# JORDAN

### JORDAN REVISION LIST - STRUCTURAL:

### MLP000683 BUYER MARKED PLAN

### JORDAN REVISION LIST - ARCHITECTURAL:

A-6.1

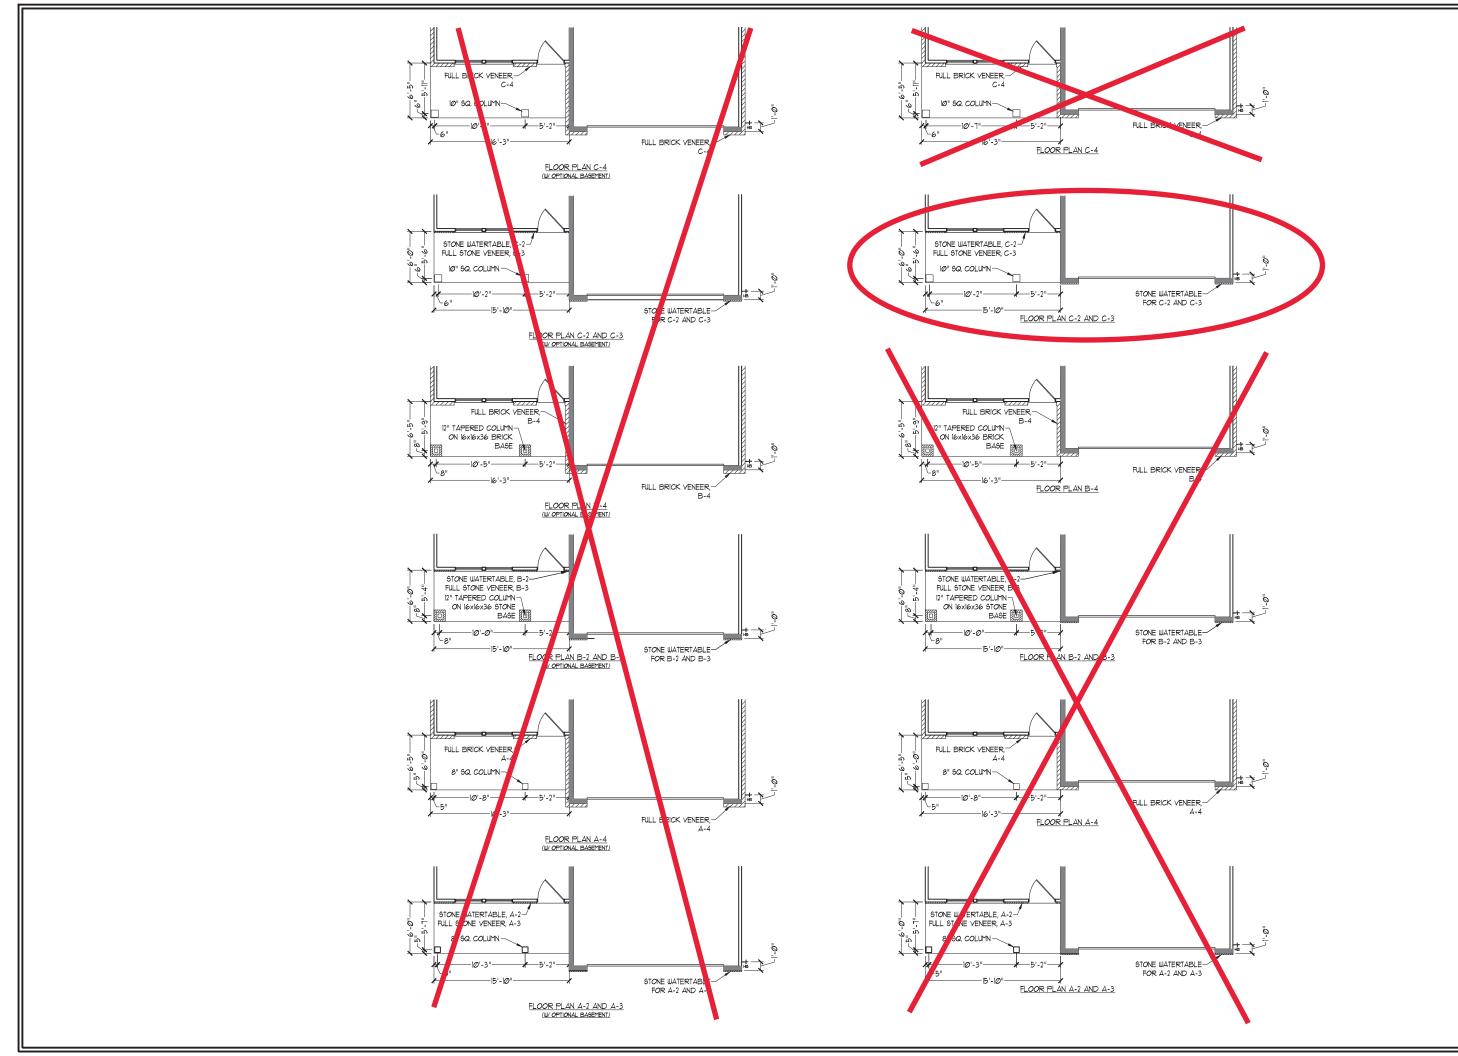
- 39.) CHANGED SWING OF SERVICE DOOR IN GARAGE TO OUT SWING (SEE SHEET A6.1) (7-8-20)
